**SUBJECT: BYRON STATION, UNITS 1 AND 2, PROBLEM IDENTIFICATION AND
RESOLUTION INSPECTION REPORT 05000454/2013007; 05000455/2013007**

Report No: 05000454/2013007; 05000455/2013007

Facility: Byron Station, Units 1 and 2

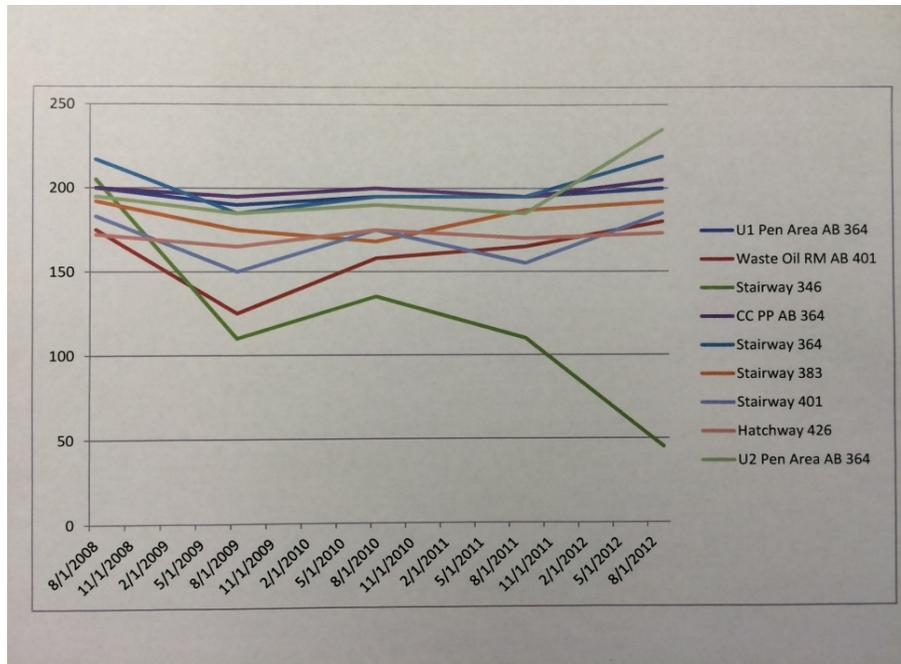
Description: On September 18, 2013, the inspectors requested that the licensee provide an explanation for the apparent degradation of the as-found pressure readings during the annual surveillance tests performed on the elevation 346' stairwell water curtain fire barrier. On August 22, 2013, visiting NRC auditors had observed a low pressure reading for one of the auxiliary building sprinkler main drain surveillance tests. The data for the 346' stairwell indicated 45 pounds per square inch gauge (psig) although other auxiliary building sprinklers indications ranged between 173 psig and 235 psig. Section 2.3.11.3 of the Fire Protection Report stated, in part, that elevation 346' of the auxiliary building had a sprinkler system provided around the stairwell at location P-18. Licensee design drawings identified that 7 psig was required for a sprinkler head to be considered operable. Because the surveillance test readings for the subject sprinkler line were identified to be as low as 45 psig, the inspectors were concerned that the minimum pressure required for each individual sprinkler head of 7 psig may not have been met. The unusually low 346' stairwell sprinkler pressure data had not been identified by licensee personnel although the surveillance data was reviewed by the Non-Licensed Operators who performed the test and by a licensed Senior Reactor Operator. The NRC auditors requested data from previously performed annual surveillance tests for this and other sprinklers and were presented with the graph below:

The PI&R inspectors determined that licensee personnel had not performed any additional follow-up and had not initiated an IR following identification of the issue. In response to inspector questions, the licensee then initiated IR 1560667, "Adverse Trend in Main Drain Results for 346 AB Sprinkler System," dated September 19, 2013, to document the adverse trend in main drain surveillance test results. The licensee also initiated corrective actions regarding the failure to initiate an IR when the adverse trend was first identified by the NRC auditors and documented this in IR 1563676, "346 AB Stairwell/Hatch Sprinkler System," dated September 25, 2013.

Based upon the data from the previously performed surveillance test, performed September 4, 2012, the licensee declared the auxiliary building elevation 346' fire curtain inoperable and initiated compensatory measures that included fire watches. Work Order (WO) 01676766 was subsequently performed on October 7, 2013, and when the mechanics opened line valve 0FP897 they determined that the stem of the ball valve was twisted. This had the effect of visually indicating that the valve was full open when, in fact, it was partially closed. Based upon the trend line in the graph, the inspectors concluded that this condition had existed for some time and likely degraded further during previously performed activities.

As part of the licensee's corrective actions, the licensee replaced the bent isolation valve stem. In addition, as-found pressures were taken before the isolation valve was repaired, a hydraulic analysis was performed to more accurately assess past system operability, the engineering staff was added to the list of personnel who received the surveillance test data, and the engineer who failed to initiate the IR received additional training and counseling.
